**RE: Antelope Creek (Kings Point North) initial Submission Review Response to Comments  
CN#: 2022-6050-00; 2022-3081-00**

# KINGS POINT NORTH ANTELOPE CREEK INFRASTRUCTURE SITE PLAN

SHEET 2 OF 5

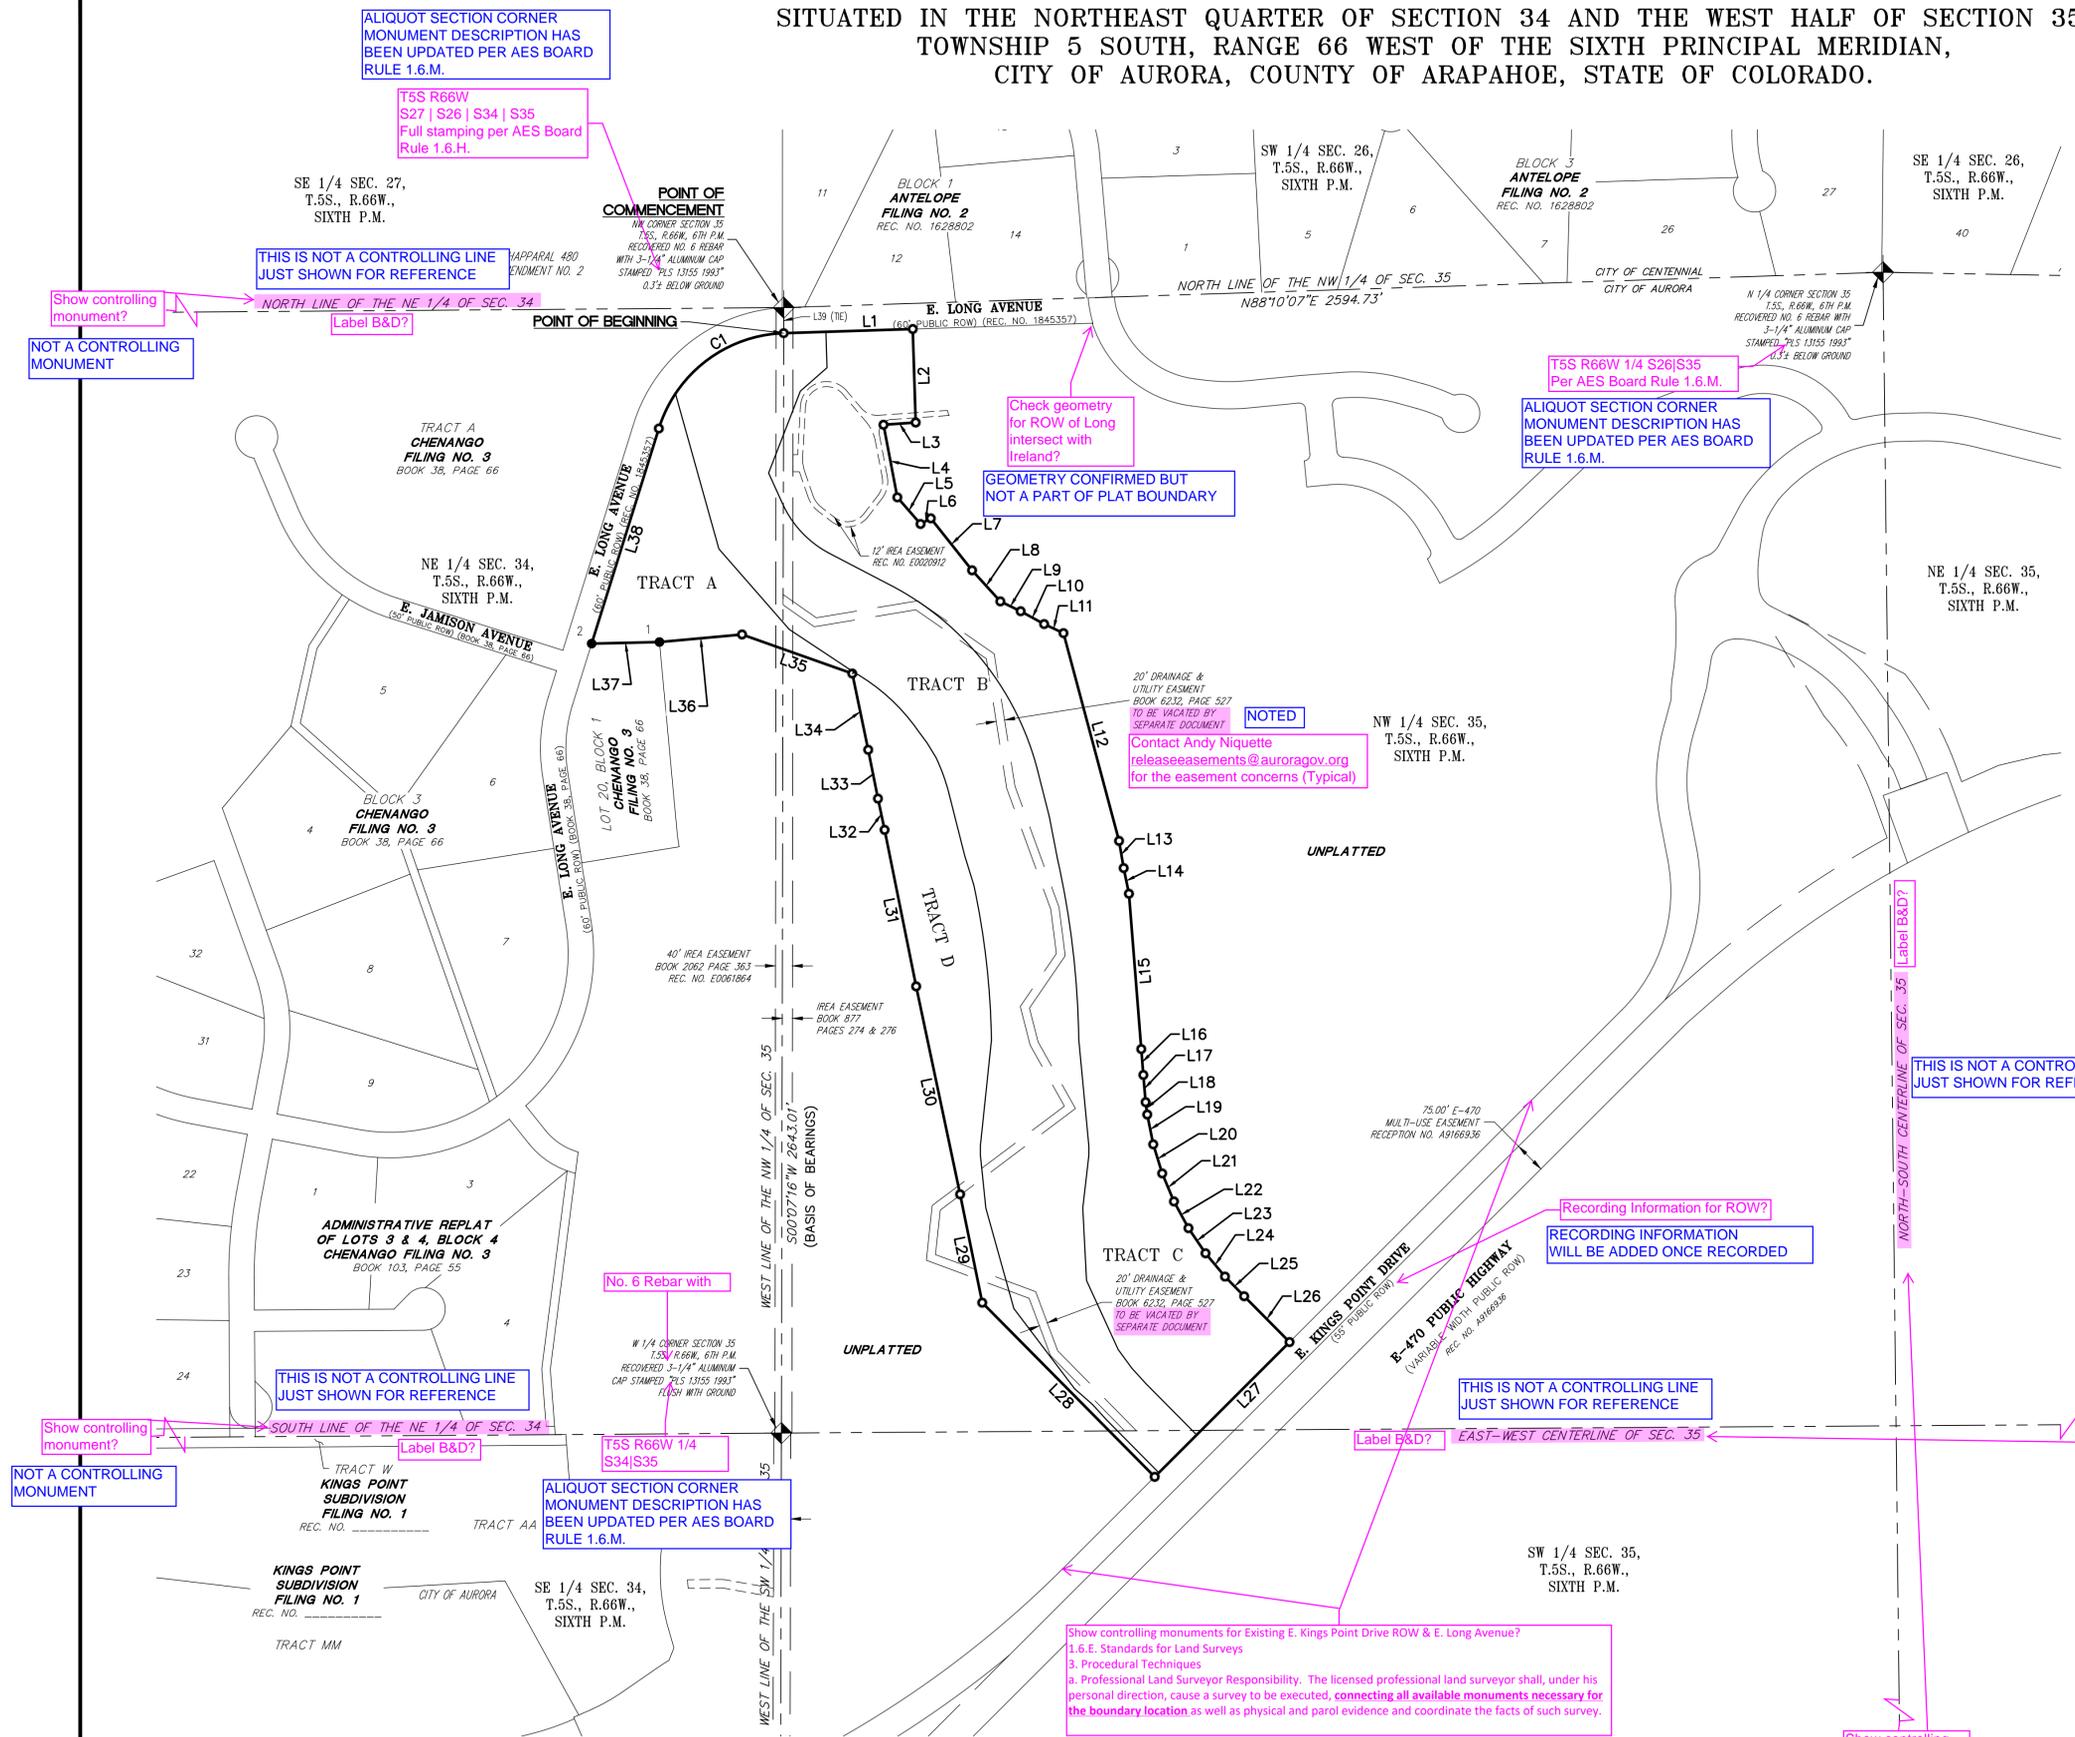
Show controlling monuments for Existing E. Kings Point Drive ROW & E. Long Avenue?  
1.6.E. Standards for Land Surveys  
3. Procedural Techniques  
a. Professional Land Surveyor Responsibility. The licensed professional land surveyor shall, under his personal direction, cause a survey to be executed, connecting all available monuments necessary for the boundary location as well as physical and parcel evidence and coordinate the facts of such survey.

**RESPONSE: This ROW is proposed has not been monumented at this point in time.**  
[Plat Page 3]
- x. See comments on sheet 2 of 5.  
**RESPONSE: See redlines**
